UNITED STATES PATENT AND TRADEMARK OFFICE

APPLICATION NO.	FILING DATE	FIRST NAMED INVENTOR	ATTORNEY DOCKET NO.	CONFIRMATION NO.
10/563,886	05/18/2006	Katri Keski-Nisula	PLA078-820713	7030
54942 7590 01/18/2008 WOLF, BLOCK, SHORR AND SOLIS-COHEN LLP 250 PARK AVENUE 10TH FLOOR NEW YORK, NY 10177				
EXAMINER PATEL, YOGESH P				
ART UNIT		PAPER NUMBER		
4111				
NOTIFICATION DATE		DELIVERY MODE		
01/18/2008		ELECTRONIC

Office Action Summary

DETAILED ACTION

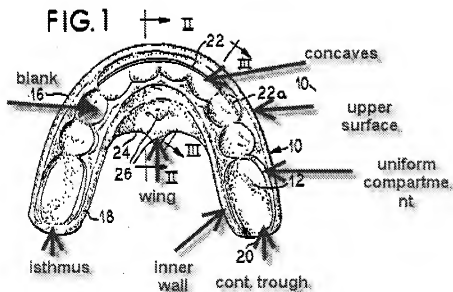
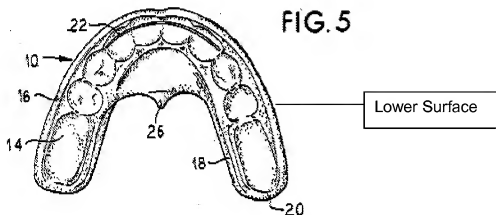
21. Claims 1-5 are rejected under 35 U.S.C. 102(b) as being anticipated by Bergersen (Pat. 4,784,605).

Regarding claim 1, Bergersen discloses an odontological device including a generally U-shaped arch that has a lower surface on the lower jaw side and an upper surface on the upper jaw side, and concaves forming an isthmus separating the concaves and the walls of the concaves are formed by the outer walls on the labial or buccal side, respectively, and of inner walls arranged on the opposite sides of the concaves on the lingual side of the tongue; the isthmus between the concaves having recesses, a part of which are meant for individual teeth, wherein the recesses consist of uniform compartments, which start from the second premolar and continue towards the molars at least partially to the area where the second permanent molar will erupt (see the figures below). Regarding claim 2, Bergersen discloses uniform compartments that are

formed by outer and correspondingly inner walls, which have essentially straight walls (see figures below). Regarding claim 3, Bergersen discloses the uniform compartments are shaped like continuous troughs 12, and the troughs are open from the molar side end (see the figures below). Regarding claim 4 Bergersen discloses the recesses contain limited to the area of the front teeth, and the walls of the recesses are essentially smooth-surfaced (col. 2, lines 35-40). Regarding claim 5, Bergersen discloses the concaves have their own blanks for canine teeth and the first premolars (see the figures below).

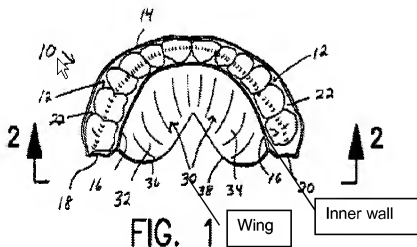
Bergersen '420 teaches many arrangements may be incorporated in a dental appliance to address different problems by varying the thickness of the isthmus (col. 6, lines 49-57). For example, for overbite corrections, a thickness of the isthmus increases at the anterior region relative to the posterior region as compared with the normal occlusion

design would optimally be between 4 to 5 mm thereby causing the anterior teeth to be depressed 1 to 2 mm before contact of the posterior teeth is possible. Similarly, by increasing the thickness of the isthmus in the posterior region relative to the anterior region, an open bite can be corrected. The variation in thickness of the isthmus is occurs in step because the thickness is different in anterior and posterior portions. It would have been obvious to a person of ordinary skill in the art at the time of the invention was made to have provided a varying thickness of the isthmus of the device as taught by Bergersen'420 to the orthodontic device of Bergersen to correct open bite and overbite problems (col. 6, lines 49-67 and col. 7, lines 19-42).
